E8364BH85-07**S E R V I C E N O T E**Supersedes:
NONE**E8364BH85 PNA Series RF Network Analyzers****Serial Numbers: MY00000000 - MY47040116****Add-on mechanical components to enhance instrument reliability****To Be Performed By: Agilent-Qualified Personnel or Customer with specific product repair knowledge – requires instrument disassembly and component replacement.****Parts Required:**

Further design review has suggested the addition of a clamping mechanism to ensure that the 8121-0118 ribbon cable can not vibrate loose from the Test Set Motherboard connector during extreme handling.

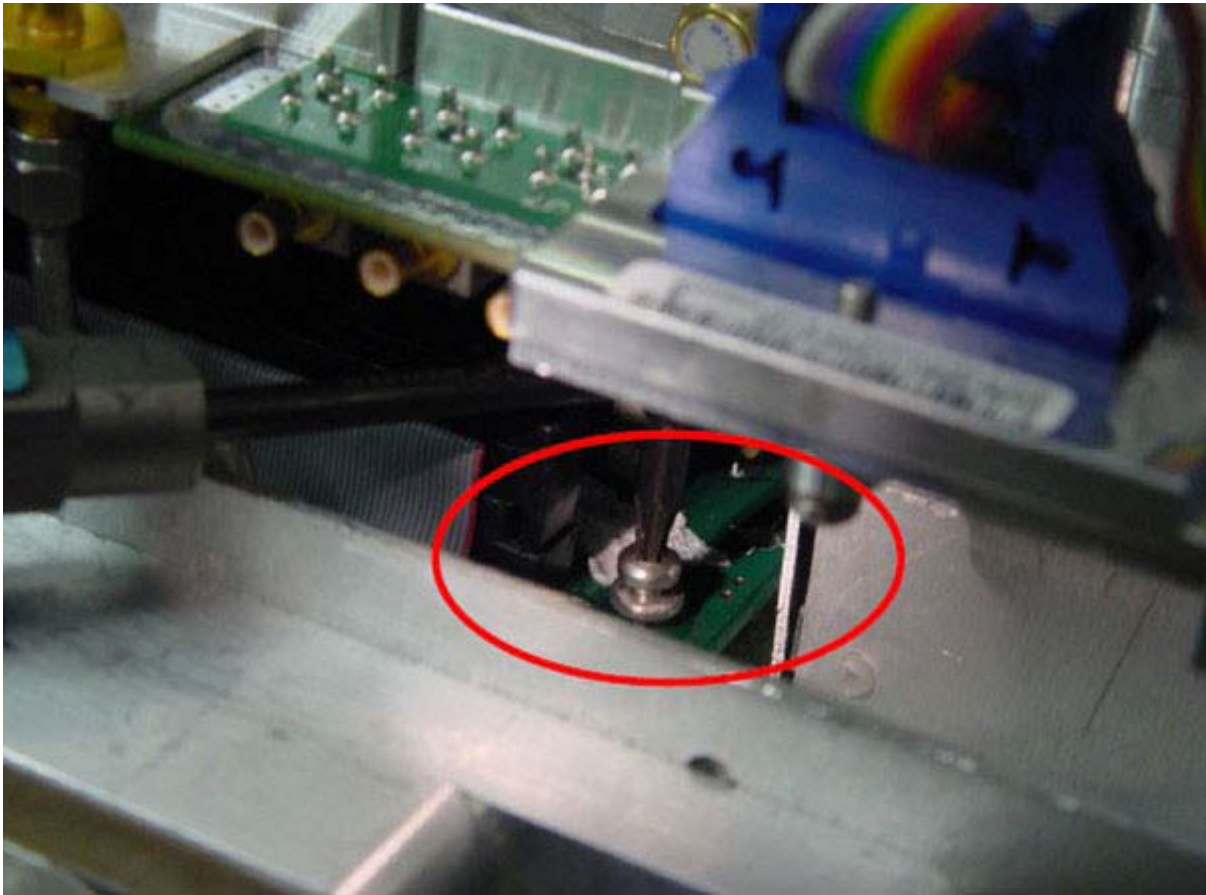
- b. Remove the open end head by loosening set screw. It will be replaced with L-Key shown below.

McMaster Carr item 6959A18 (T-10 torx size L-key)

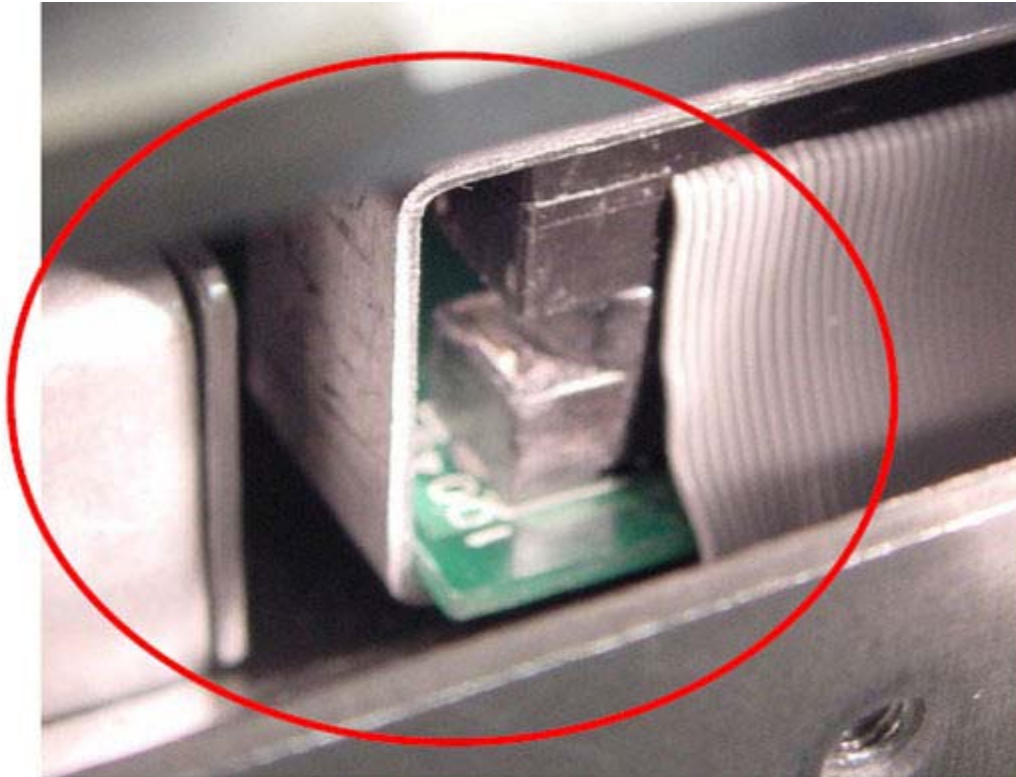
- b. Insert Ribbon Cable Clamp under Source Assembly as shown.

- c. Position the clamp over the Ribbon Connector. Use needle nose pliers if necessary to slide the clamp into place. Ensure that the edge of the clamp is parallel to the connector and not skewed.

NOTE: Ensure that the Clamp Lip is secured BELOW the edge of the System Motherboard

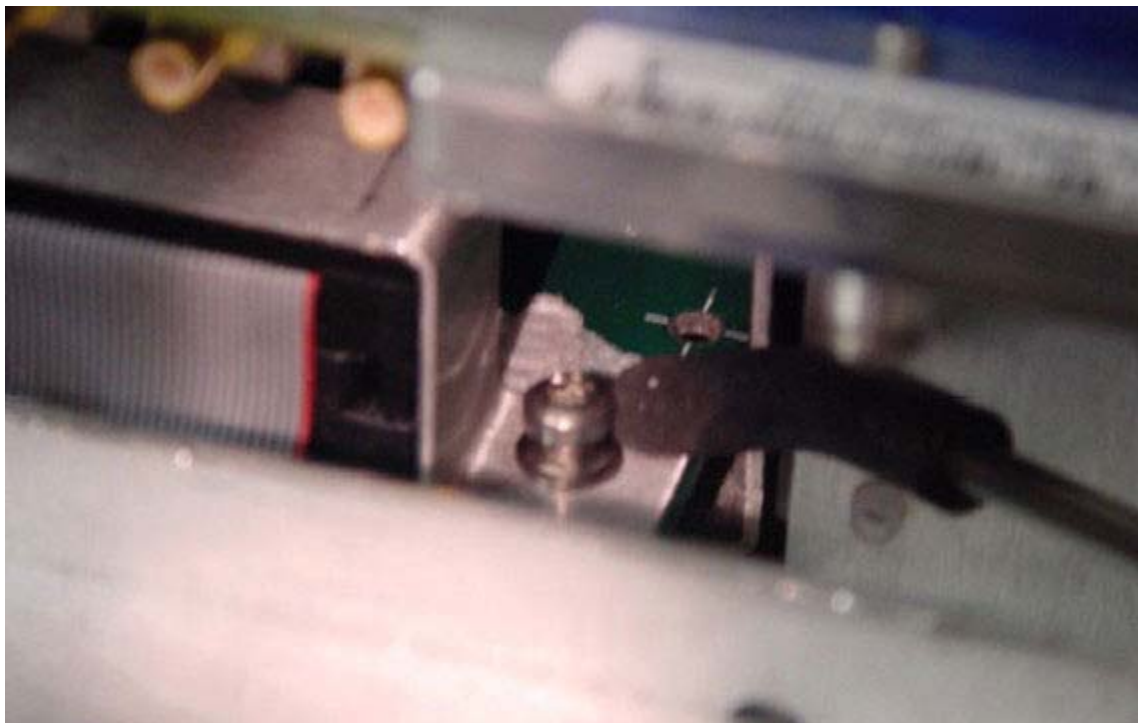
- d. Using tweezers, install a new 0515-0374 screw through the hole in the bracket.

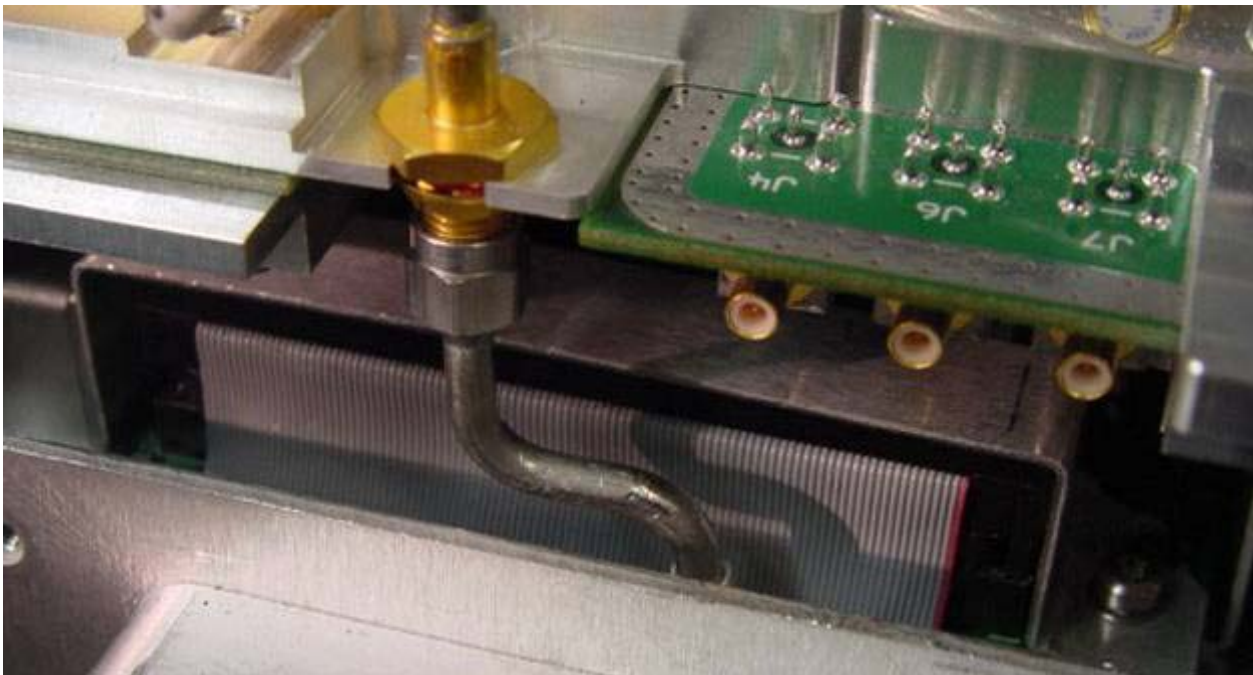
- g. This image shows the final position of the secured clamp.

Figure 2a

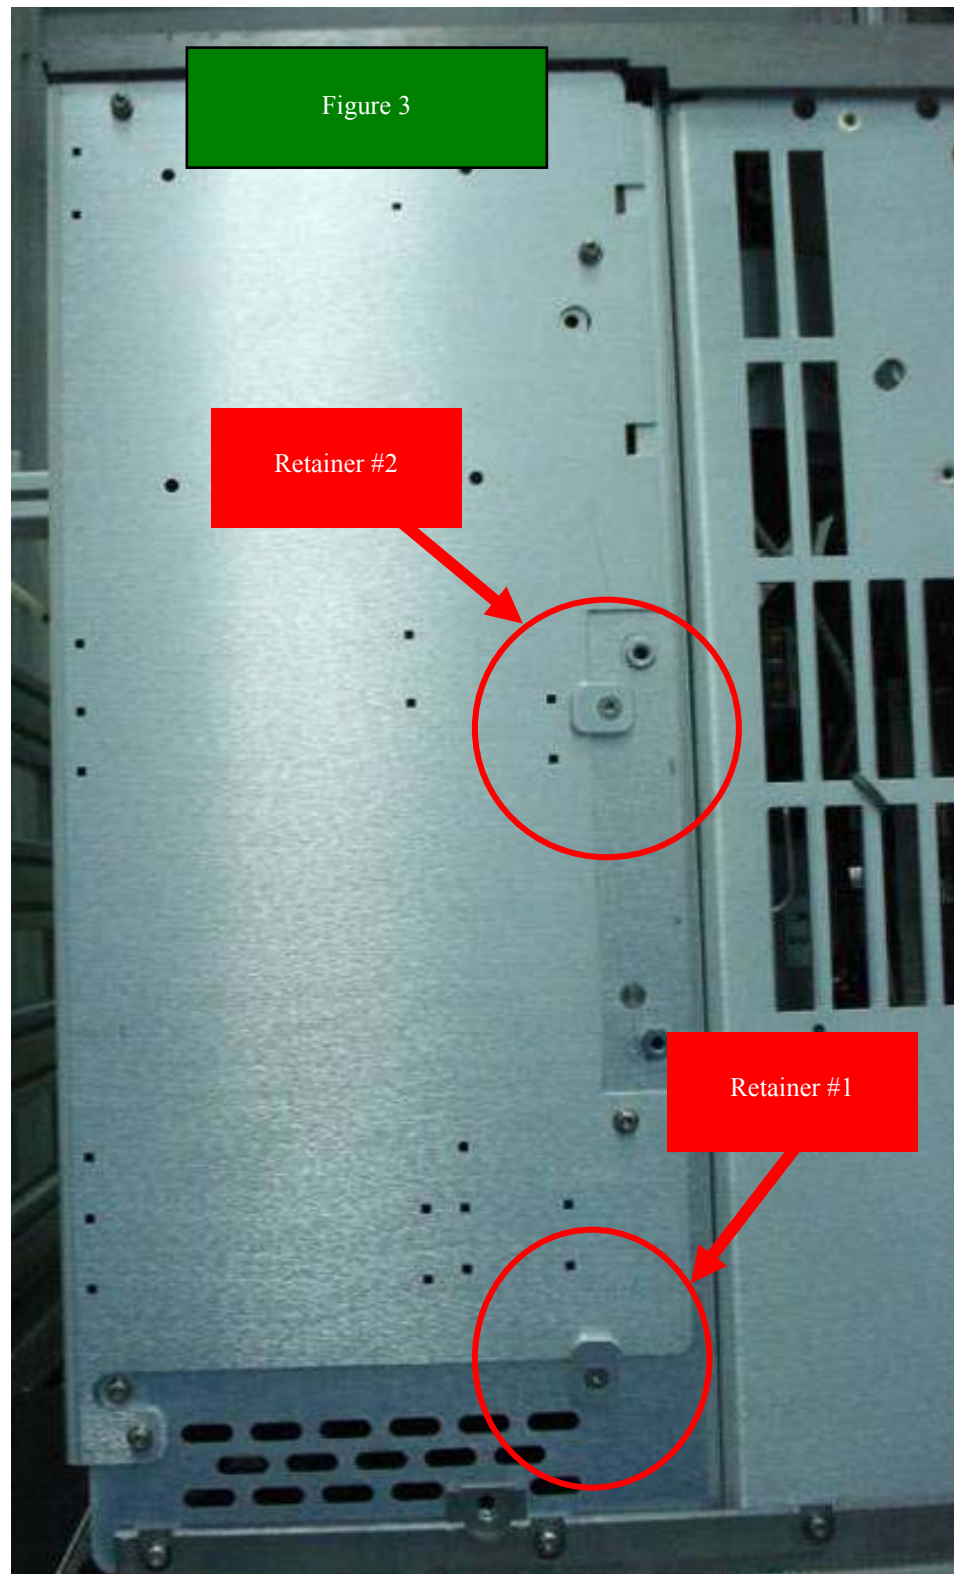
The Clip Retainer (E8361-20067) to be secured with Flat Head screw (0515-1644) in 2 places at 9 lb-in. This Retainer Clip may naturally rotate a bit when being secured, which is acceptable. Note that the existing screw needs to be removed and discarded prior installing Retainer Clip #1 (shown below in Figure 2a, 2b, and 3).

Figure 2

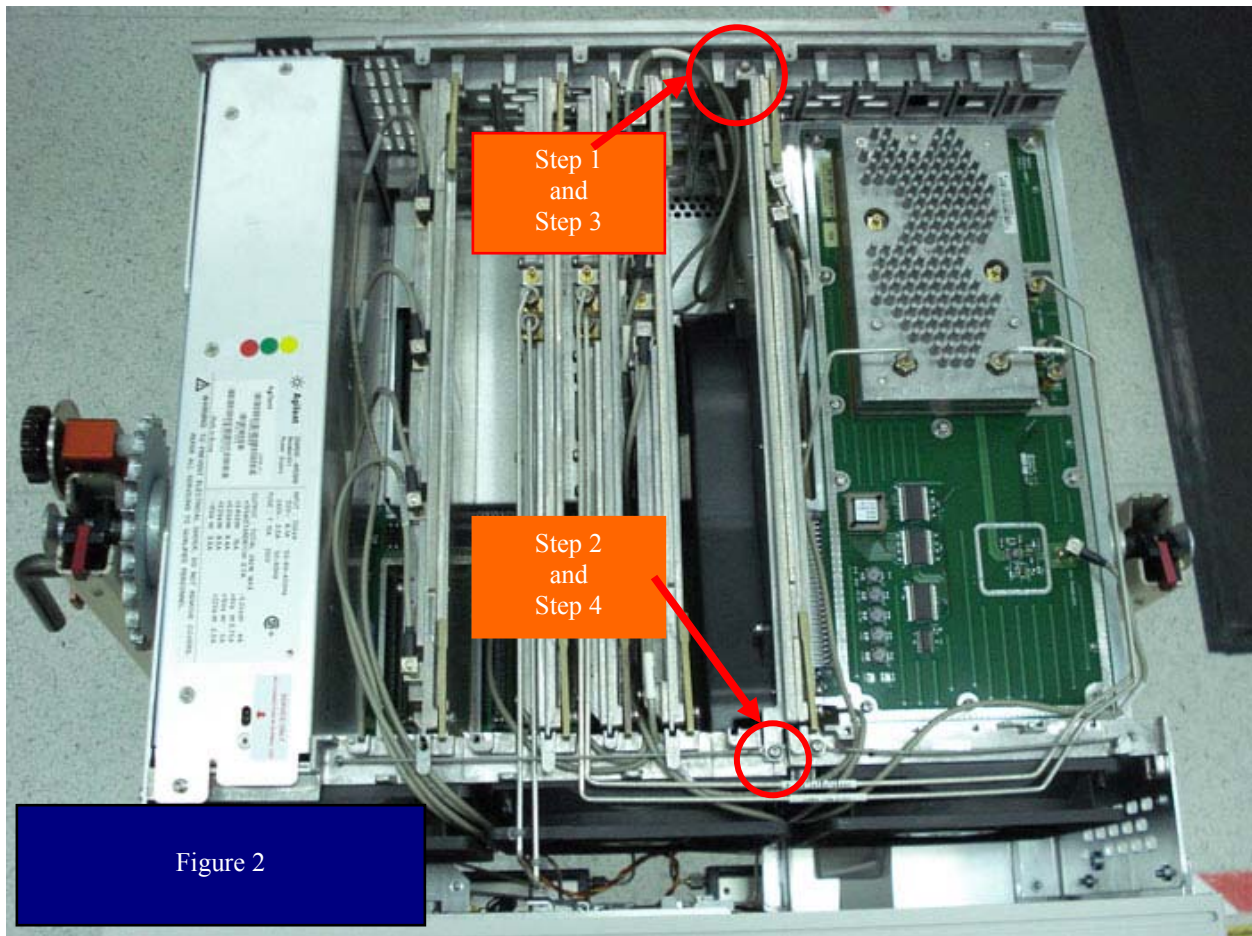
The Patch-Lock Screw (0515-2799) and Flat Washer (3050-0891) to be used in 2 places and secured at 9 lb-in. These parts will replace existing screw (0515-0374) used in Step 3 and Step 4 (as shown in Figure 2) to secure the Phase Lock Board (E8364-60137).
